**Rezoning from “Residential (Group C) 2” (“R(C)2”) and “Open Space” (“O”) zones to
“R(C)4” zone for a Proposed Residential Development
at Lot Nos. 519 RP (part) and 520 RP in D.D. 110 and adjoining Government land,
and
Rezoning from “R(C)2” to “O” zone
at Lot Nos. 121, 137, 138, 139 S.A and 139 RP (part) in D.D. 110
and adjoining Government land, Shek Kong, Yuen Long, N.T.
(S12A Amendment of Plan Application No. Y/YL-KTN/6)
- Further Information No. 5 -**

In response to the departmental comments from Transport Department (TD) received on 17 and 20 July 2026, we hereby submit a response-to-comment table with the Revised Traffic Impact Assessment.

Proposed Rezoning of the Application Site from (i) “Residential (Group C) 2” and “Open Space “ Zones to “Residential (Group C) 4” Zone for a Proposed Residential Development at Lot Nos. 519 RP (part) and 520 RP in D.D. 110 and adjoining Government land and (ii) from “Residential (Group C) 2” to “Open Space” Zones at Lot Nos. 121, 137, 138, 139 S.A and 139 RP (part) in D.D. 110 and adjoining Government land at Shek Kong, Yuen Long, N.T. (S12A Amendment of Plan Application No. Y/YL-KTN/6)

Comments Forwarded from Fanling, Sheung Shui and Y

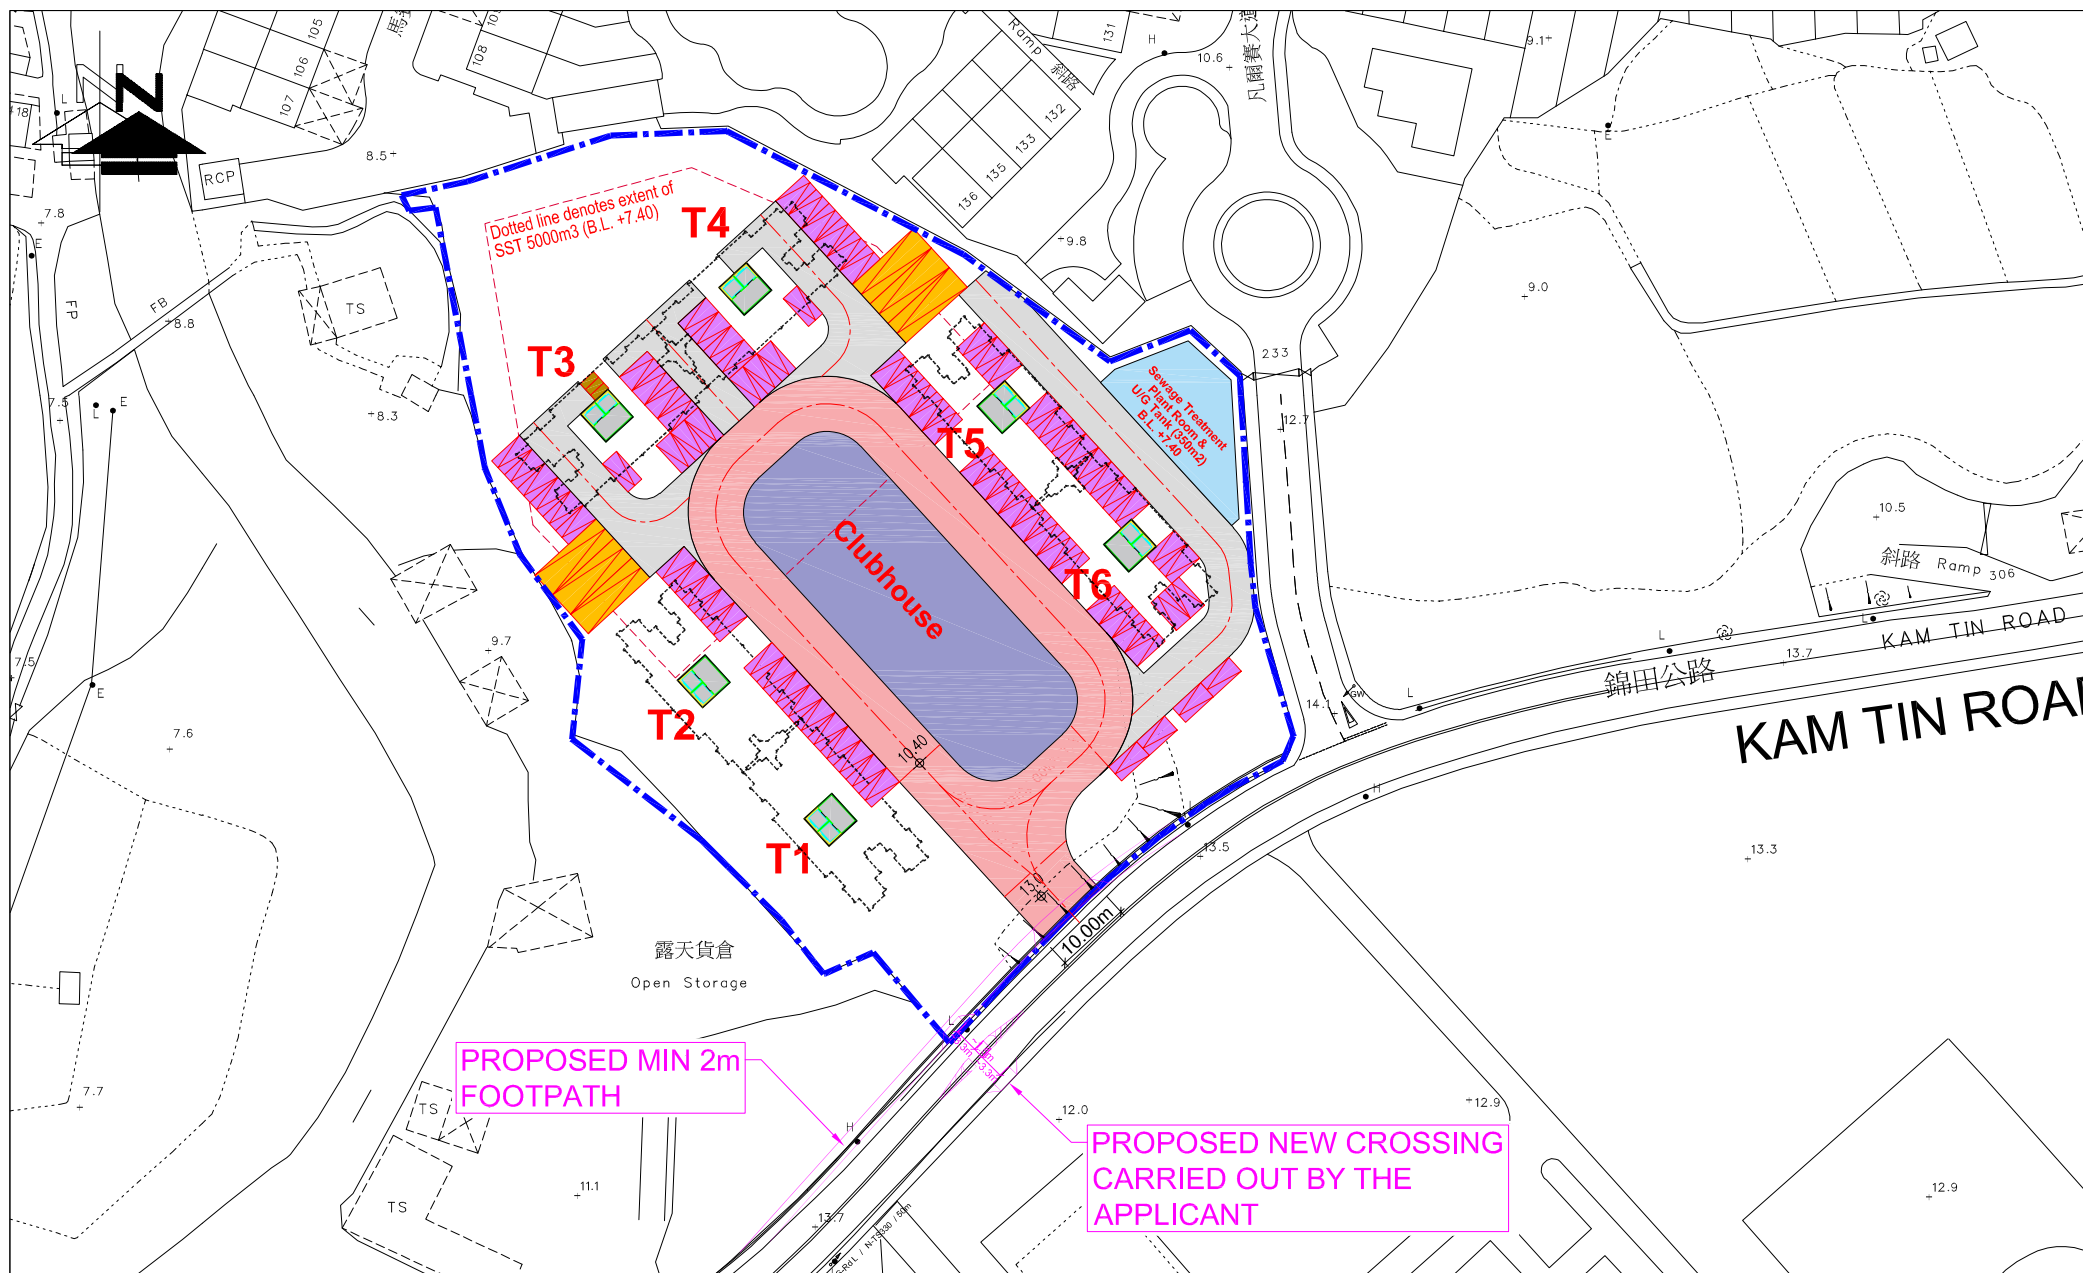
Figure 2.3 - The location of L/UL space is designed away from the towers, e.g. T1 and T6. This could be reviewed during detailed design stage.	Noted. The location of L/UL spaces will be reviewed during the detailed design stage.
Figure 7.3 - According to the TIA, the current footpath along Kam Tin Road at both sides are approx. 1.5m wide. However, due to the presence of street furniture such as beam barriers, lamppost, railing etc., the pedestrian flow arisen from the development may have difficulties going to / from the adjacent attraction, e.g. public transport. The applicant should review	Noted. It is proposed to locally widen the northern footpath of Kam Tin Road to min. 2m as shown in Figure 7.3 of the TIA report.
